Construction Change Directive

PROJECT: <i>(Name and address)</i> Hidalgo County Remodel Old Admin Bldg 100 E Cano Edinburg, Texas 78539	DIRECTIVE NUMBER: 005	OWNER <input checked="" type="checkbox"/>
TO CONTRACTOR: <i>(Name and address)</i> D Wilson Construction P.O. Box 3455 McAllen, Texas 78502	DATE: April 05, 2014	ARCHITECT <input checked="" type="checkbox"/>
	CONTRACT FOR: General Construction	CONSULTANT <input checked="" type="checkbox"/>
	CONTRACT DATED: October 23, 2012	CONTRACTOR <input checked="" type="checkbox"/>
	ARCHITECT'S PROJECT NUMBER:	FIELD <input type="checkbox"/>
		OTHER <input type="checkbox"/>

**1st AND 2nd FLOORS REMODEL
 FORMER ADMINISTRATION BUILDING
 HIDALGO COUNTY, TEXAS**

FIRST FLOOR PLAN
 SCALE: 1/8" = 1'-0"

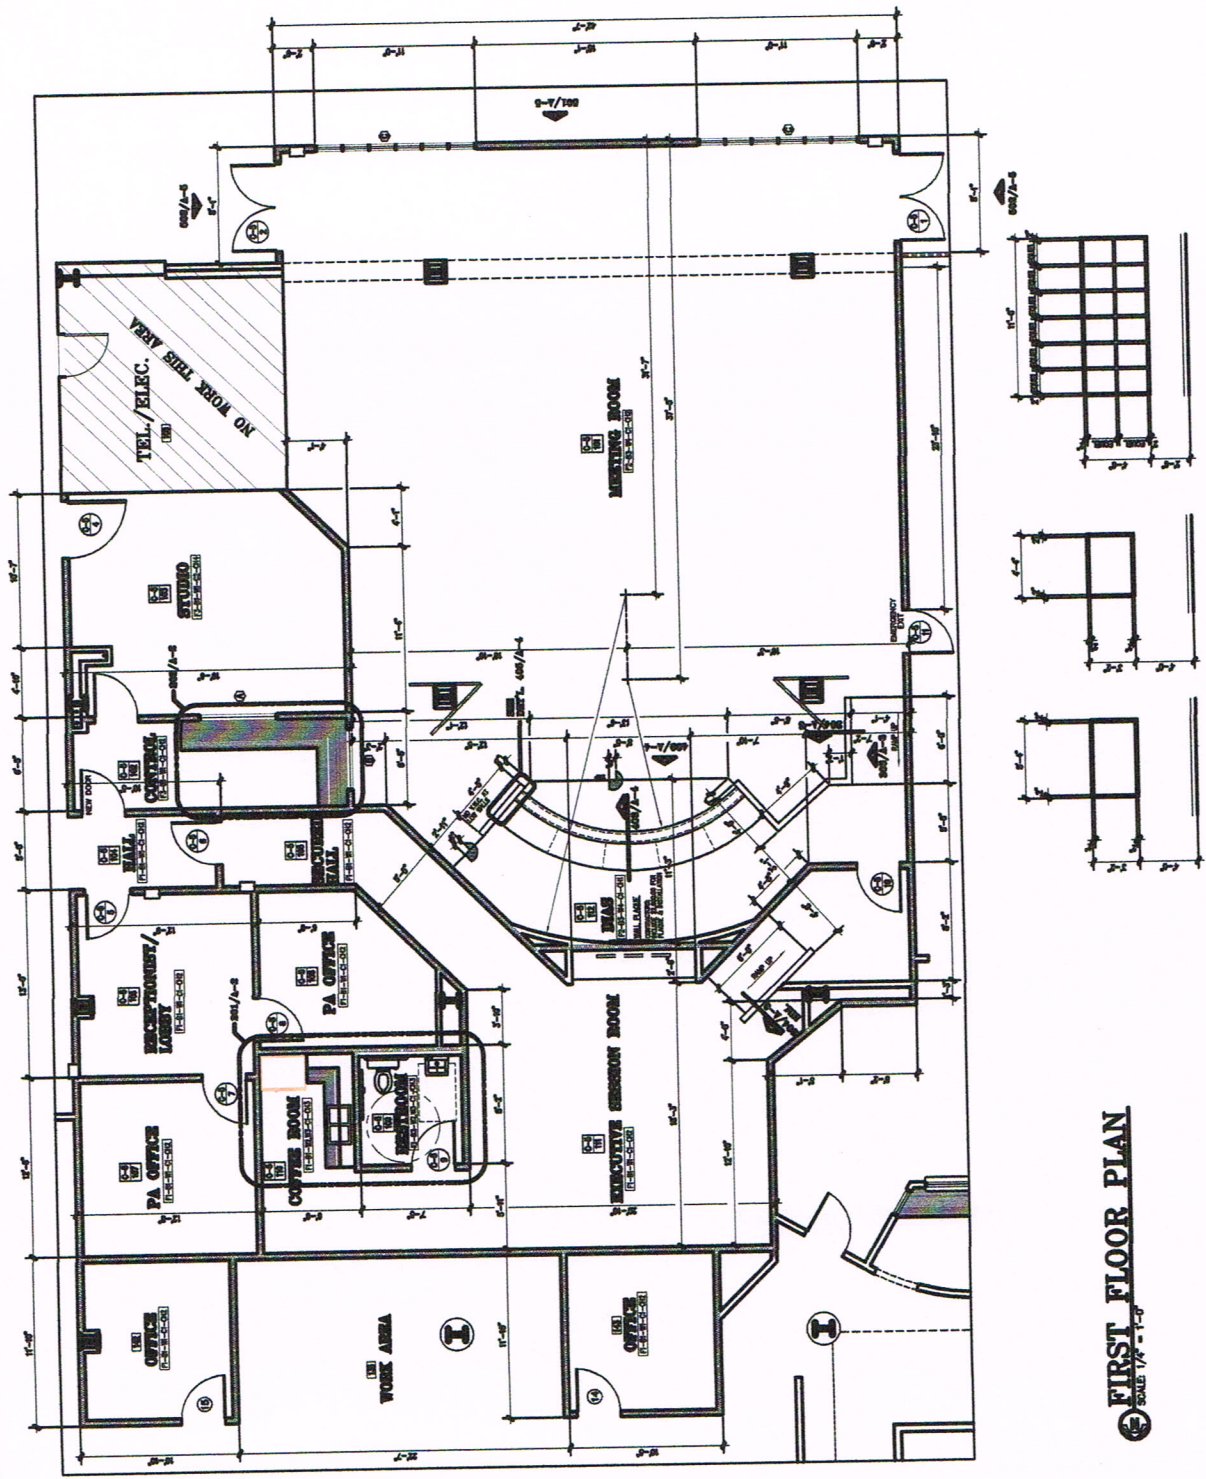
1. Removal of existing quarry tile and mortar bed at First Floor of West Wing. Provide new mortar bed. Finish to receive new ceramic tile flooring.....\$10,049.00 (includes GC oh/p)
2. Concrete Floor Expansion Joint Material-First Floor....\$3,479.00 (includes GC oh/p)
3. Floor Leveling, 1st and 2nd Floors.....\$2,761.00 (includes GC OH/P).
4. Revisions to Commissioners Court Meeting Room and Public Affairs Offices...Cost Pending
5. Revisions to District Attorney's Offices.....Cost Pending
6. Add the amount of \$1,600.00 credit from door hardware to project allowance (New Project Allowance \$6,027.00).

Please submit cost proposal for the removal and disposal of approximately 2,000 s.f. of existing quarry tile flooring and mortar bed at West Wing of the Old Administration Building.

Labor and material cost for new mortar bed. Prepped to receive new 20"x20" ceramic floor tile. Top of new finish mortar bed to be flush with adjacent concrete slab.

D. Wilson construction Company, reports an existing expansion joint in the slab and recommends that this joint be prepared by installing a Crack Isolation Membrane or Dalseal TS over this joint.

2.) To furnish & install 10,000 sq. of Mapeilastic CI, Crack Iso. Membrane at plumbing trenches.
